CHANGE ORDER

PROJECT: MPOE Replacement – Bldg 300
 Learning Skills Testing Relocation – Bldg 100

CHANGE ORDER NO. 001
 INITIATION DATE May 11, 2021

1. DESCRIPTION OF CHANGE: Credit for unused Owner's Allowance
 - a. Requested by: District
 - b. Reason: Contract stipulation is for the Contractor to credit back to the Owner any unused Allowance amount at the end of the Project.

DATE: 09/11/2017
 PROJECT NO.: 100-11846-01-1001
 SHEET NO.: C-101

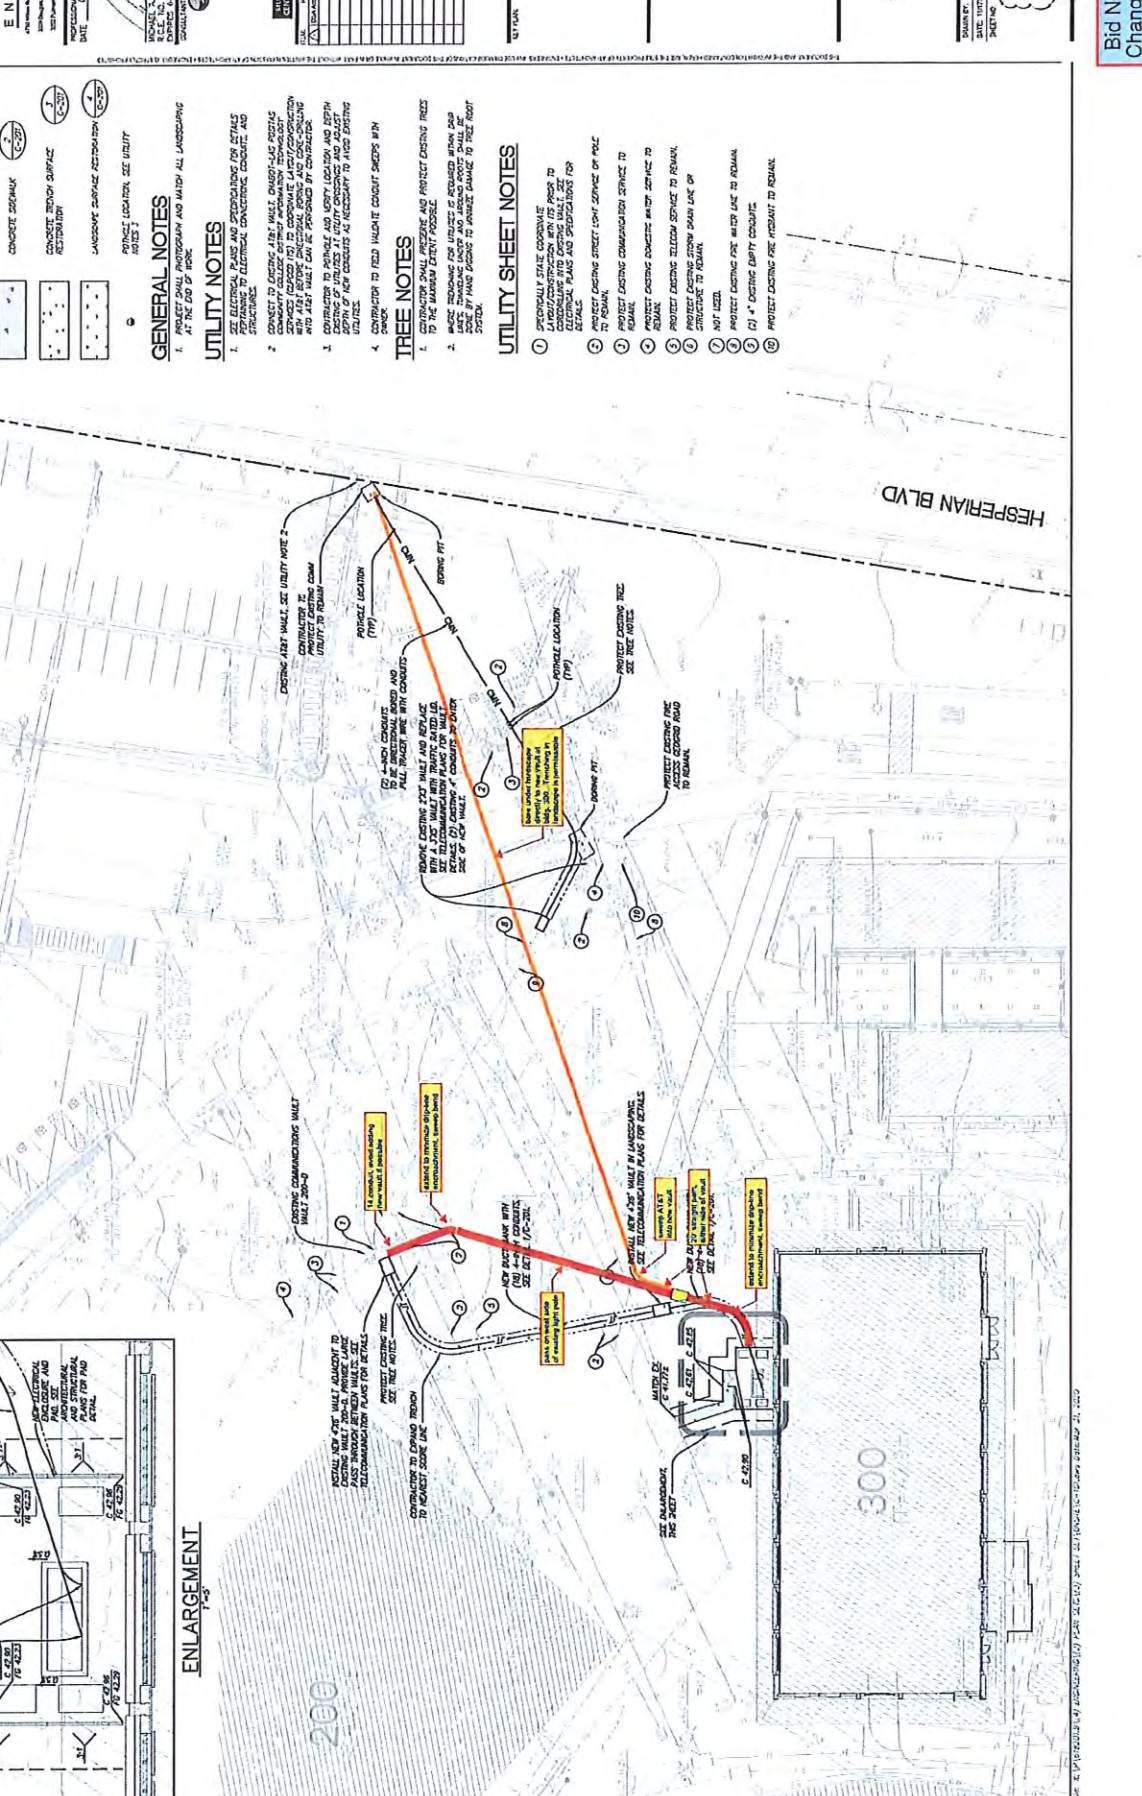
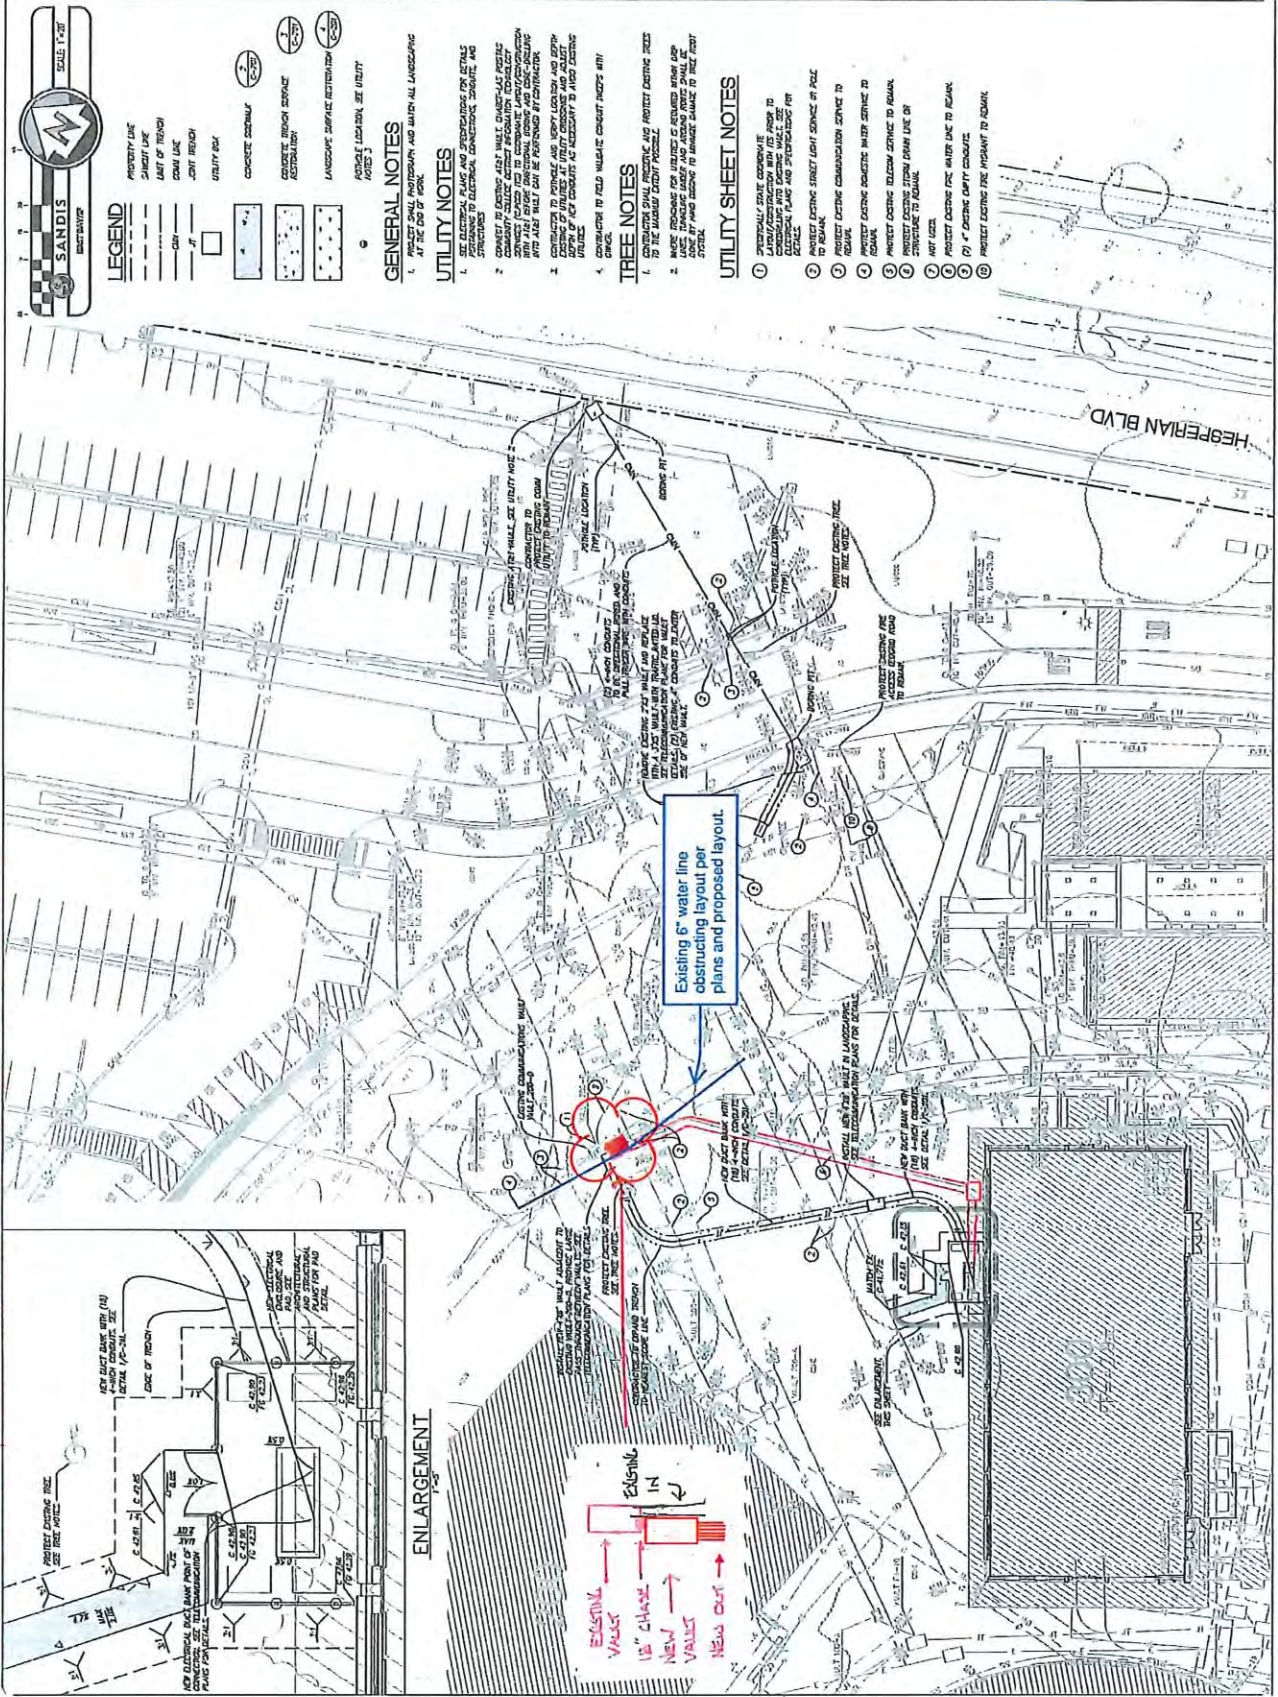
Question	Alex Tellez (Rodan Builders Inc.) on Jun 4, 2020 at 2:59 PM PDT
<p>RFI #1.2 Revised per conversation during our OAC meeting held 6/10/2020:</p> <p>See attached C-101 Utility Plan marked-up to show alternative routing for the (18) 4" Underground Conduits. We believe this to be a more direct and clear pathway. Please review and confirm this is acceptable.</p> <p>In addition, there is an existing 6" water line that is obstructing the pathway per plans and per the alternate layout proposed. See utility locating photos and report attached. Please review and advise.</p> <p>Note, Rodan Builders is pot holing this general area on Monday 6/15/20 and will provide additional supporting information to this RFI.</p>	
<p>RFI #1.1 Revised to include utility locating information:</p> <p>In addition to RFI #1 below, please review the mark-up attached showing located utilities near and around vault 200-D. Please review and advise noting pathway around the 6" DW line.</p>

<p>RFI #1:</p> <p>See attached C-101 Utility Plan marked-up to show alternative routing for the (18) 4" Underground Conduits. We believe this to be a more direct and clear pathway. Please review and confirm this is acceptable. Note, Rodan Builders is underground locating on Monday 6/8/20 and will provide additional supporting information to this RFI.</p>	
<p> RFI 001 - Alternative Routing for (18) 4-inch Conduits.pdf (See page 2)</p> <p> RFI_01.1_RBI_Alternative Routing for (18) 4-inch Conduits.pdf (See page 4)</p>

The alternate route proposed by the contractor is acceptable with the attached revisions and at no cost to the District. The final design and layout is the contractor's responsibility. The contractor is to verify existing conditions to avoid conflicts with any and all existing utilities. This proposed solution should result in a credit of at least one, possibly two vaults that will be omitted depending on how the new work connects to the existing Bldg. 200 vault. - Luke Shiras, ATI 6/19/20

DRAWING REF: FP-201

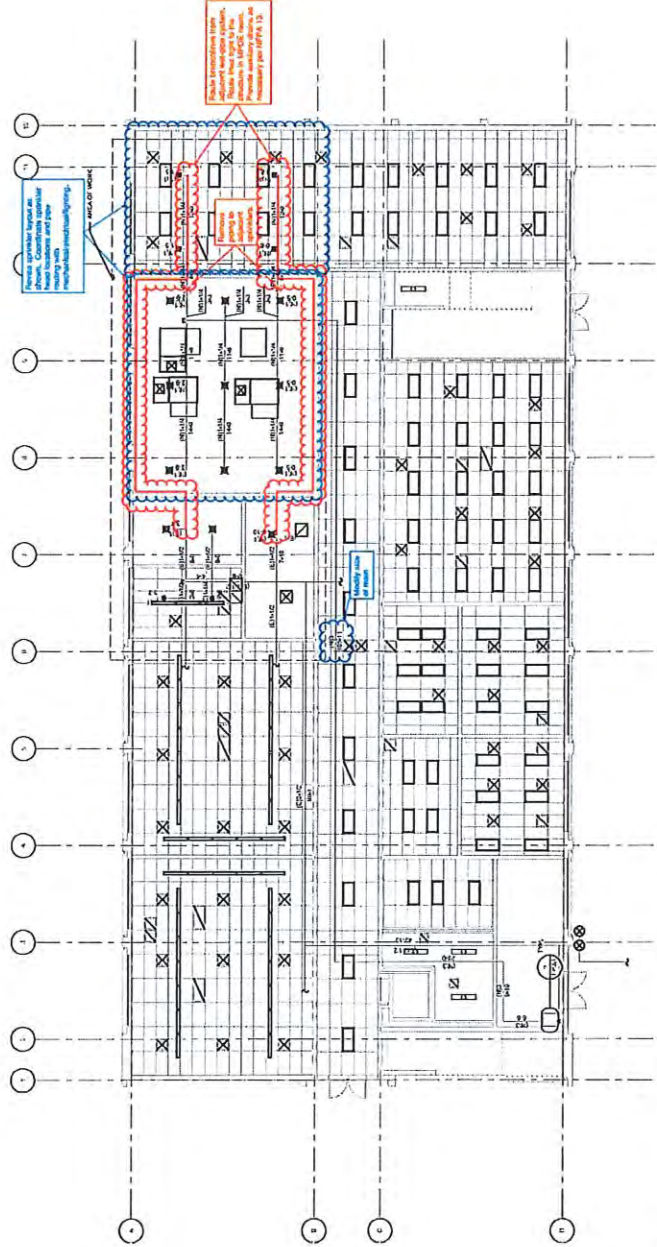
1. Design provided by EOR did not pass hydraulic calculations as you can see in the hydraulic information found in the shop drawing FP-1.1. A solution that I recommend in order for the system to work would be to upsize the main from 2" to 3" and relocate the main that enters the MPOE room to the middle of the room.
2. The MPOE room would be considered Ordinary Hazard Group 1 with 130 ft2 coverage for each sprinkler. The sprinkler heads in the design provided by the EOR does not meet spacing requirement for Ordinary Hazard Group 1. A solution that I recommend would be to add (4) additional heads in the room to meet spacing requirement.
3. The sprinkler heads in RM 308 have a spacing of 15'-8" between sprinkler heads, which can be seen on FP-201. I would recommend that we relocate the sprinkler heads to be within the 15'.

REPLY: RFI 15: The following revised floor plan with sketch will be provided as part of a CCD revising the fire protection design. 7/22/20
 RFI 15.1: The mpoe ROOM should be considered Ordinary Hazard Group I. 8/3/20

List of DSA-approved drawings affected by this post-approval document: <u>DETAIL 11/S-501</u>

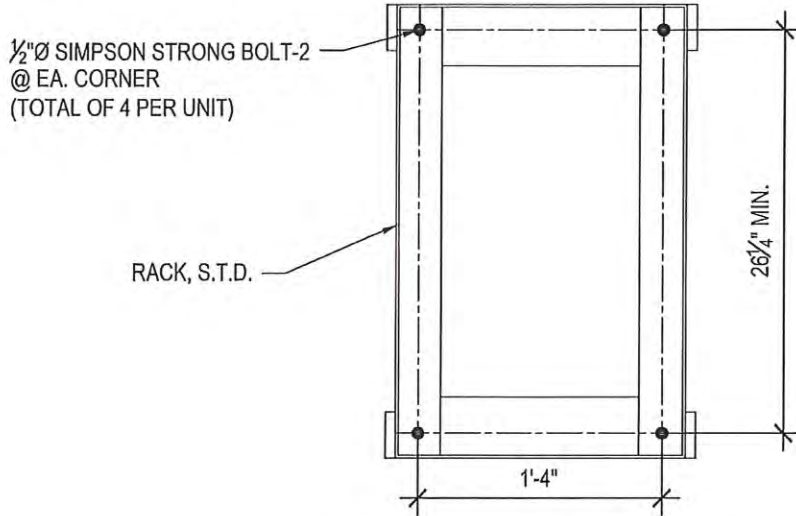
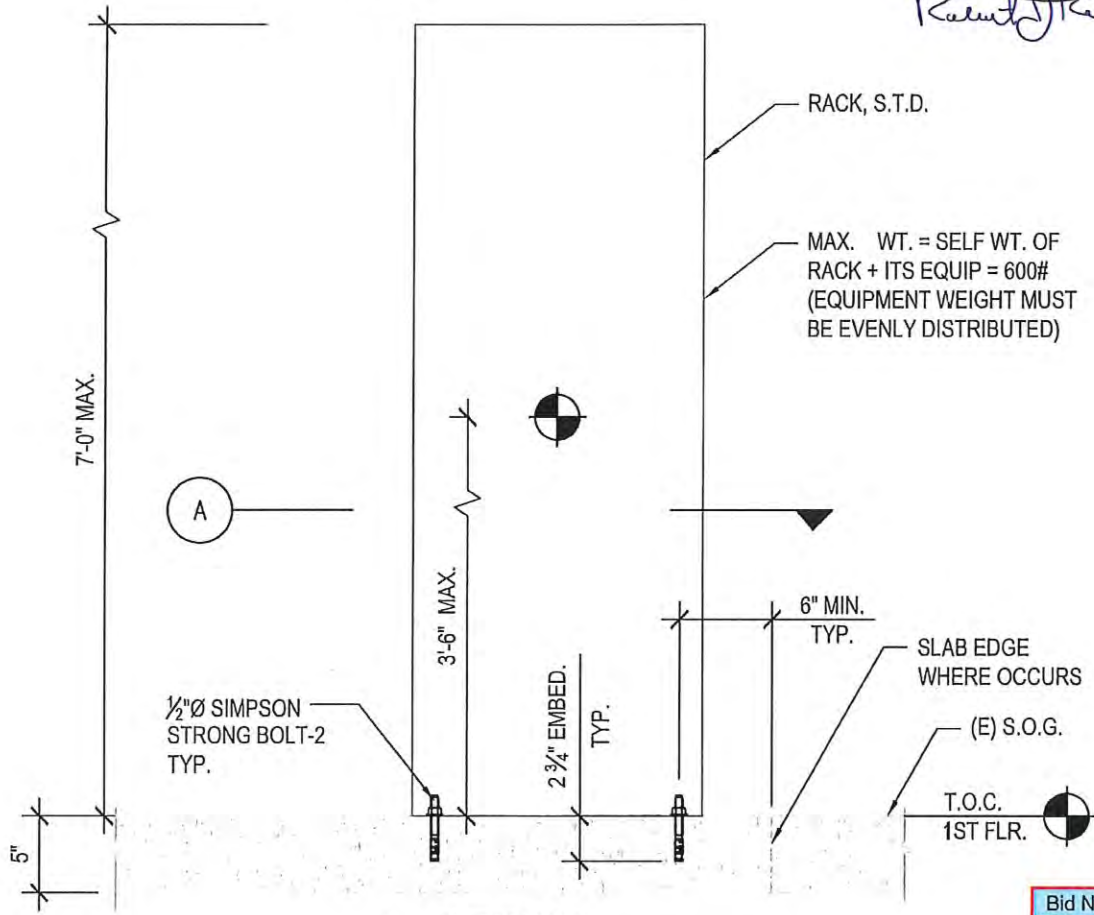
Drawing S-501 Detail 11 calls out for base plates to be installed on T18 4-post racks.

1 FLOOR PLAN - FIRE PROTECTION
 1/8" = 1'-0"

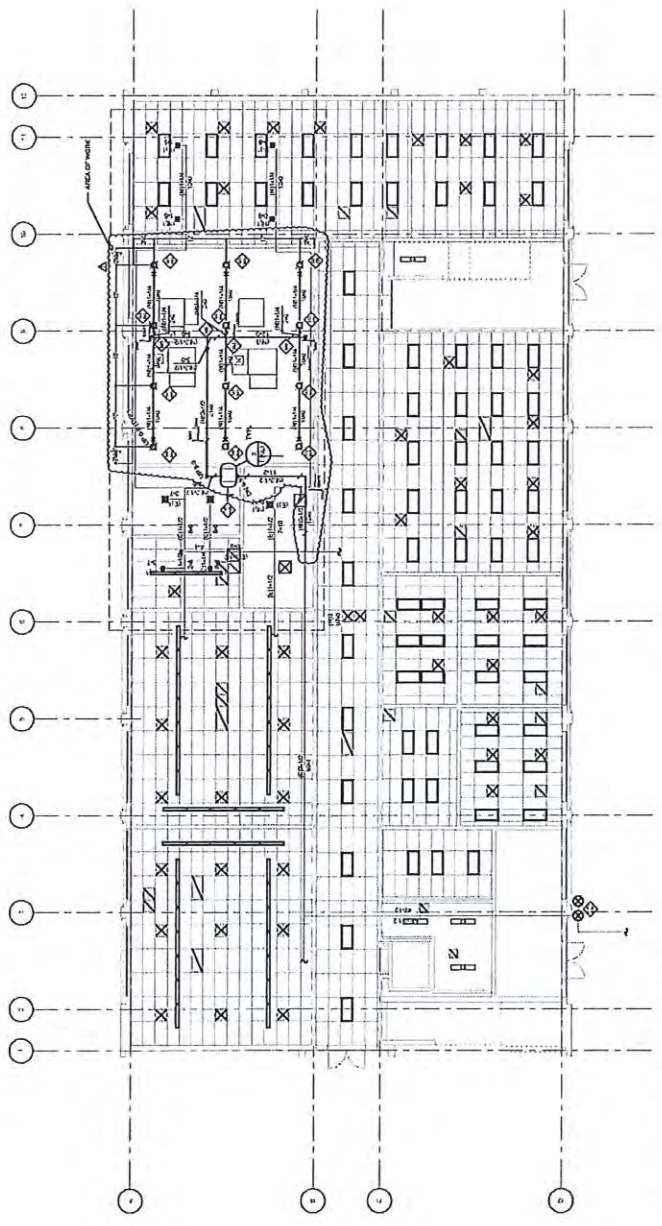
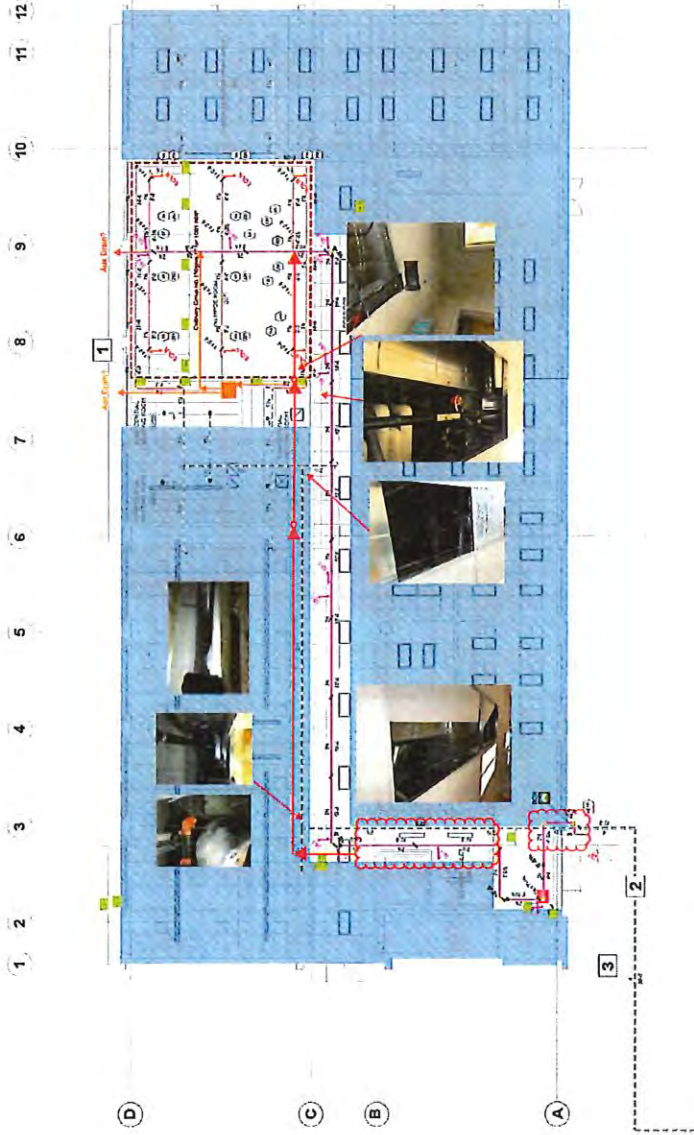
- 1. (N) 1-1/4" PIPE TIED INTO (E) WET SPRINKLER SYSTEM
- 2. (N) 2-1/2" PIPE FROM PRE-ACTION SPRINKLER SYSTEM TIED INTO (E) MANIFOLD
- 3. (N) PRE-ACTION CABINET
